Village of Lincolnwood
Plan Commission

Meeting Agenda

4. **Case #PC-06-24: Zoning Text Amendment – Zoning Text Amendment Regarding the Permissibility of a College or University in the B-2 General Business Zoning District**
   Request: Consideration of a request by the Hebrew Theological College, Petitioner and contract purchaser, on behalf of 3420 Devon Building LLC, property owner, to Amend Table 4.01.1 Permitted and Special Uses in All Zoning Districts, to allow by Special Use colleges or universities in the B-2 General Business zoning district. This hearing may also consider possible Zoning Text Amendments to a) Section 2.02 to revise the definition of the term "college or university" and to add a definition for the term "dormitory", b) Section 4.07 to establish new use regulations specifically related to a "college or university" in the B-2 zoning district, or c) Section 7.10 to establish minimum off-street parking requirements for a college or university with dormitories. The Plan Commission may consider any additional amendments to other relevant provisions of the Zoning Ordinance discovered during this case.

5. **Case #PC-07-24: 3420 West Devon Avenue – Approval of Specia

L2.00

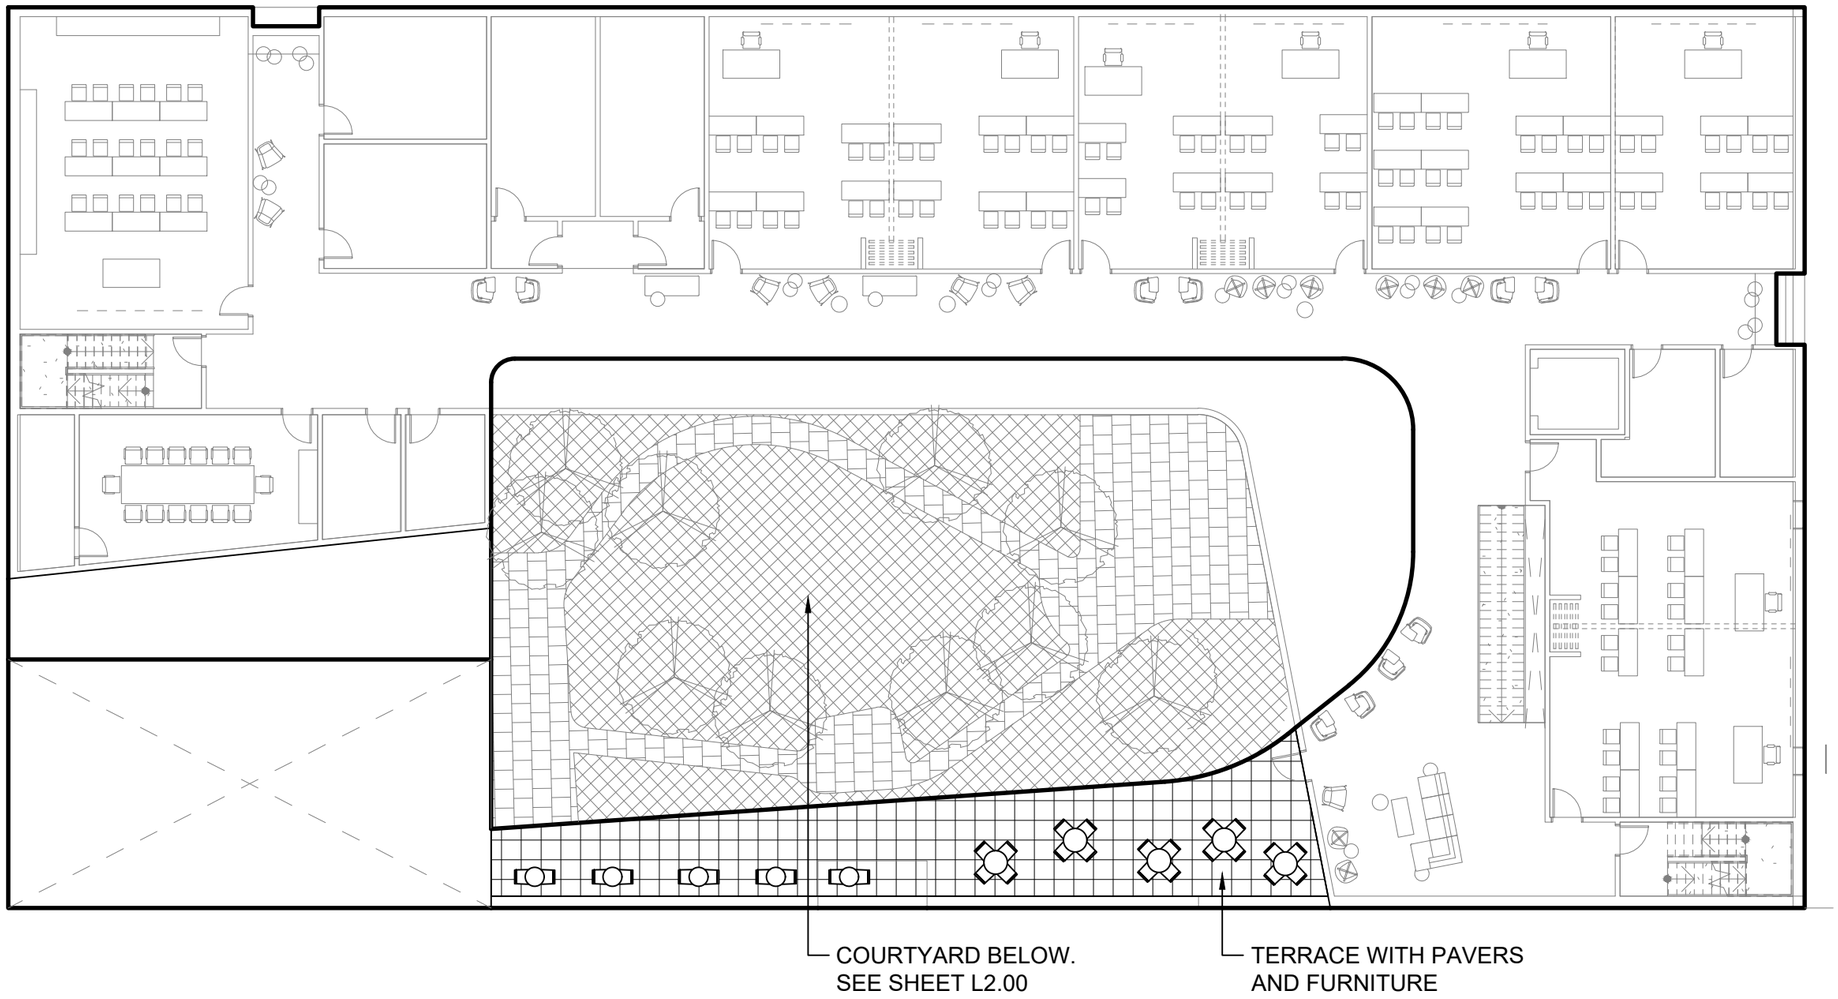
- **Sheet L2.00 indicates 1 QR in very close proximity to one of the site lights. Please adjust the landscape plan to accommodate the light.**

ORIGINAL ISSUE: 05/09/2024
KHA PROJECT NO. 168200005
SHEET NUMBER
C1.0

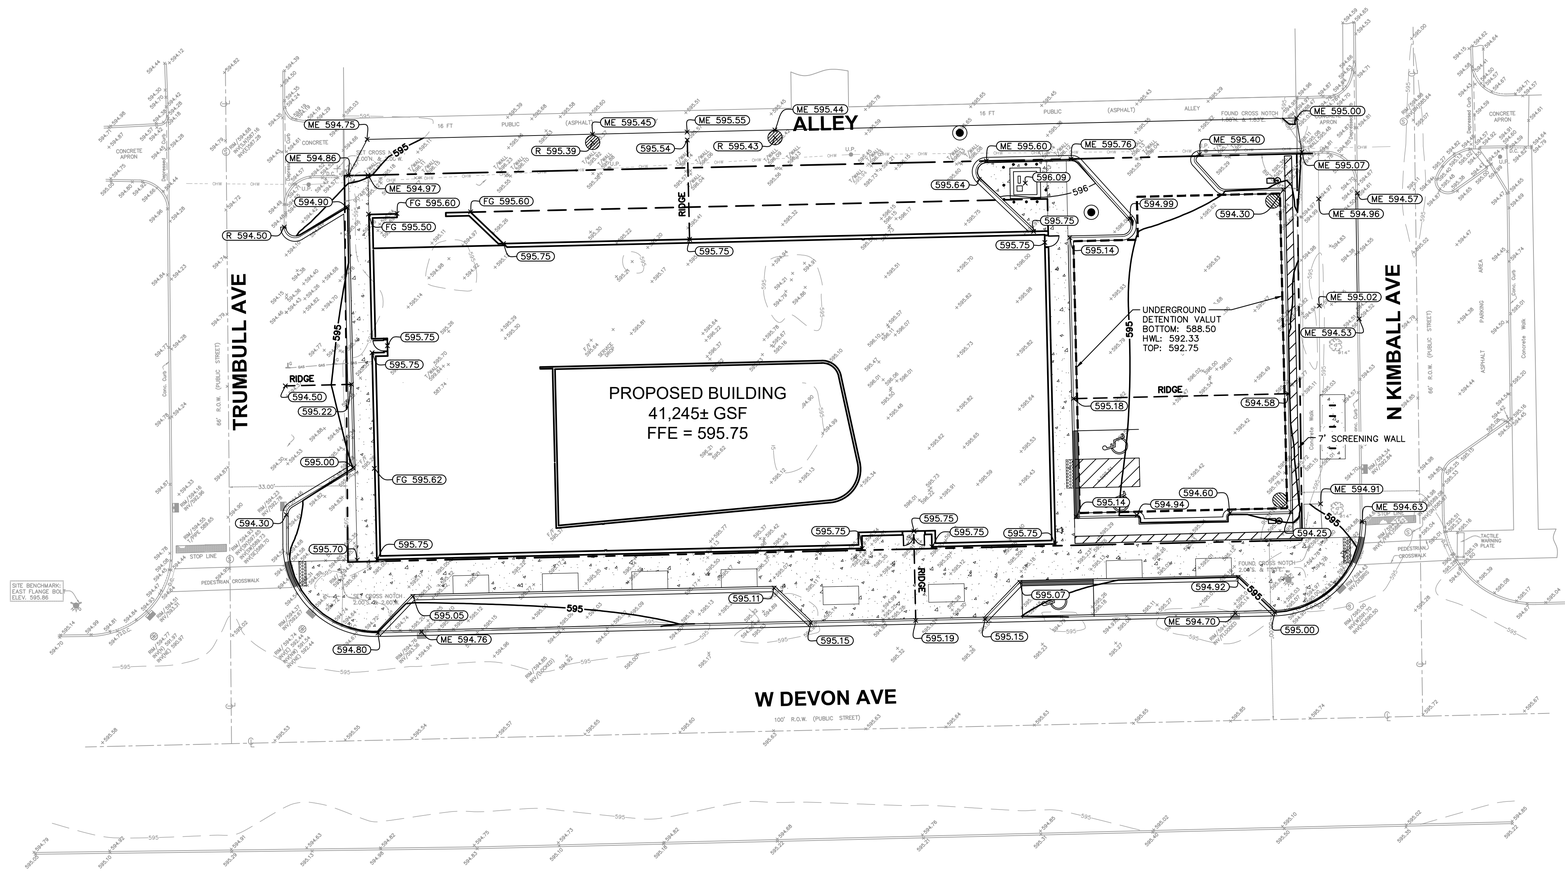
- **The location of the required bike rack (item 19) on sheet C1.0 is not found on the Landscape plan as noted in the Key Notes.**

- Please provide manufactures product sheet and indicate the location of the proposed Bike Racks as indicated on Sheet C1.0 keynote 19.

- Key Note items 8, 9, 12, 14, and 15 are not found on the plan view of sheet C1.0. if these items are not used, they should be removed from the Notes or called out as (NOT USED).

Response: Please see revised sheet C1.0 of the updated Civil Plans.

Response: All three (3) utility poles will be protected by bollards. Proposed striping and curbing will provide additional protection. Please see revised sheet C1.0 of the updated Civil Plans.

Response: Please see revised sheet C1.0 of the updated Civil Plans.

Response: Please see revised sheet C1.0 of the updated Civil Plans.

ORIGINAL ISSUE: 05/09/2024
KHA PROJECT NO. 168200005
SHEET NUMBER C2.0

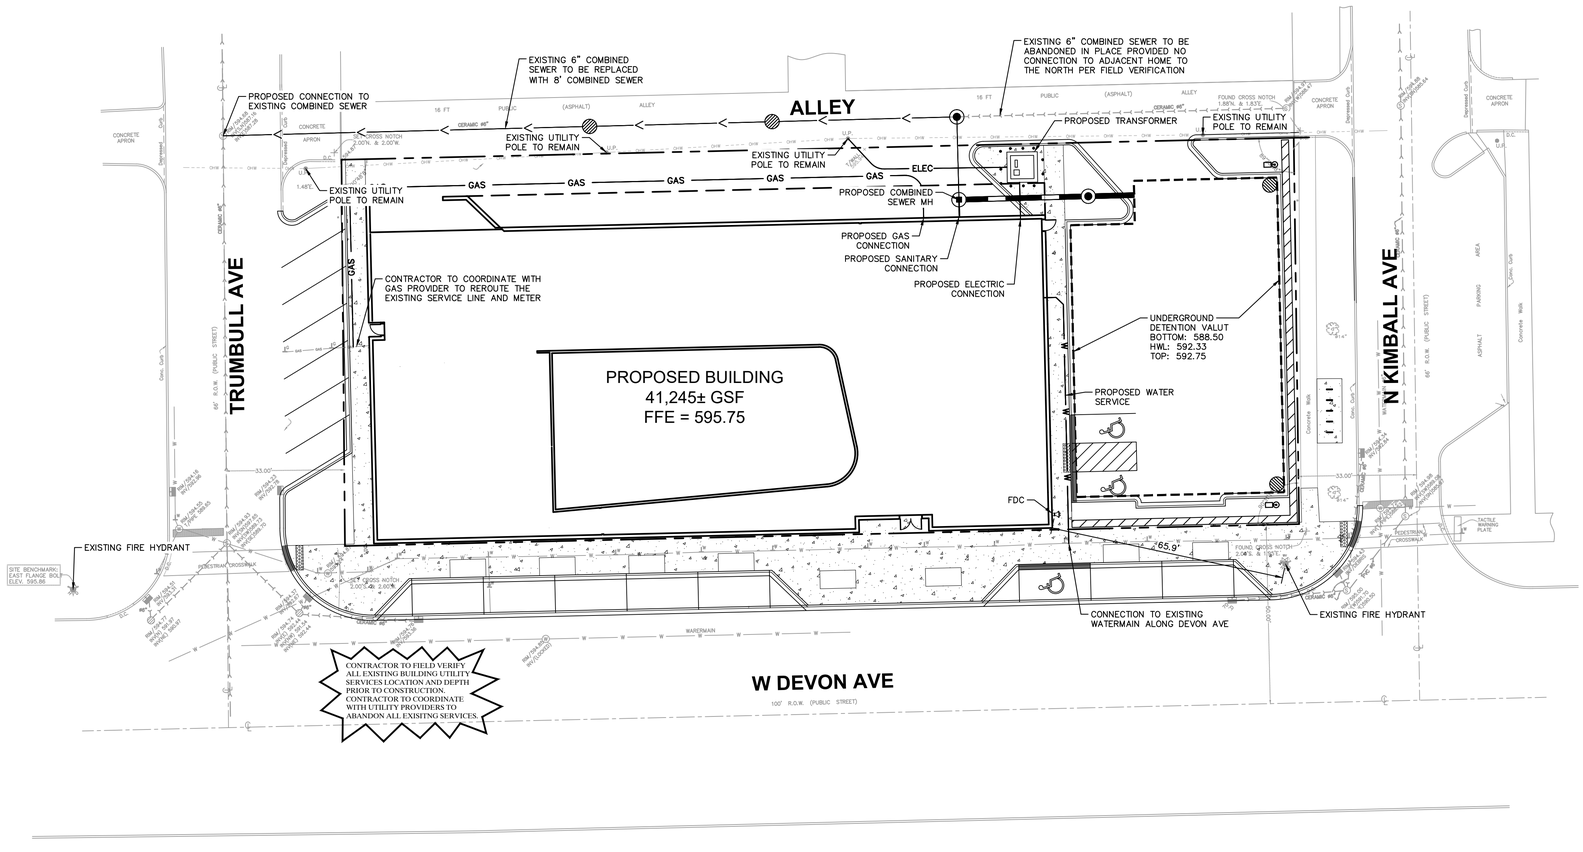
- No preliminary stormwater calculations were provided with the submittal except values placed on sheet C2.0. We do not concur with the information in the STORMWATER SUMMARY that states that 0.19 Acres of the site is considered maintenance for the purposes of calculating

Response: Noted. A preliminary stormwater summary for the rate and volume control is included on sheet C2.0 of the updated Civil Plans. Final stormwater management calculations and details will be provided with the final engineering plans.

Response: Noted. The preliminary stormwater summary on sheet C2.0 of the updated Civil Plans has been revised accordingly.

Response: Noted. The preliminary stormwater summary on sheet C2.0 of the updated Civil Plans has been revised accordingly.

ORIGINAL ISSUE: 05/09/2024
KHA PROJECT NO. 168200005
SHEET NUMBER C3.0

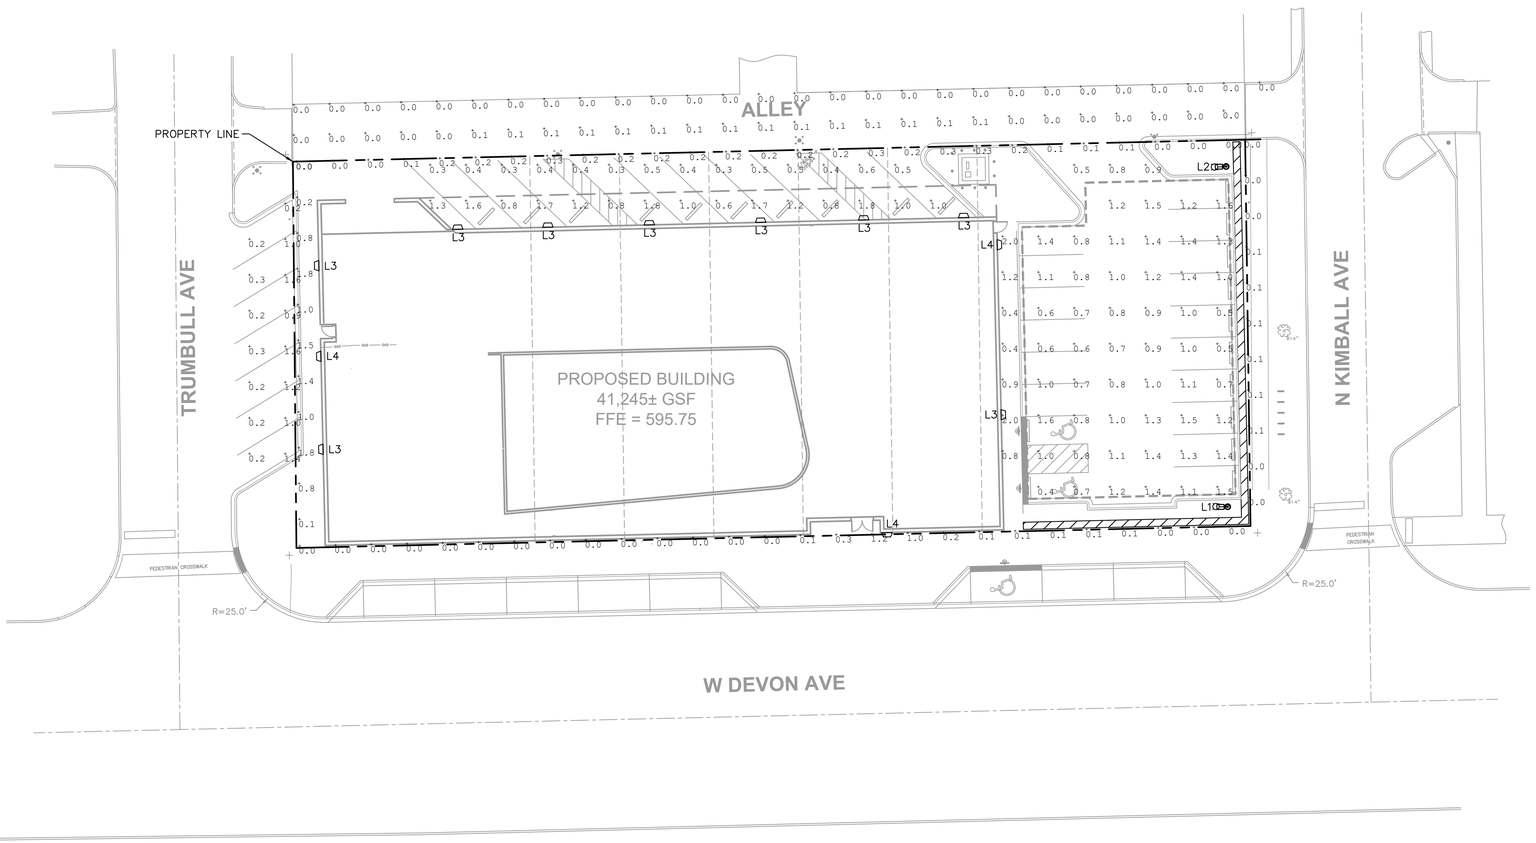
- Neither the Topographic Survey nor the Preliminary Engineering plans identify the locations of the existing water and sanitary sewer services and if they are to be reused. The existing sanitary line exits from the rear of the existing building and flows to the north. The existing water service location is not identified. It appears that both lines will not be reused per information on sheet C3.0. The locations of the existing services will need to be identified and they need to be called out for disconnection at the public mains.

Response: The Surveyor will verify location of existing utility connections. These services will not be re-used, and new taps have been proposed on the Utility Plan which is shown on revised sheet C3.0 of the updated Civil Plans.

Response: The proposed pipeline has been replaced with an 8" pipe as shown on Sheet C3.0 of the revised Civil Plans.
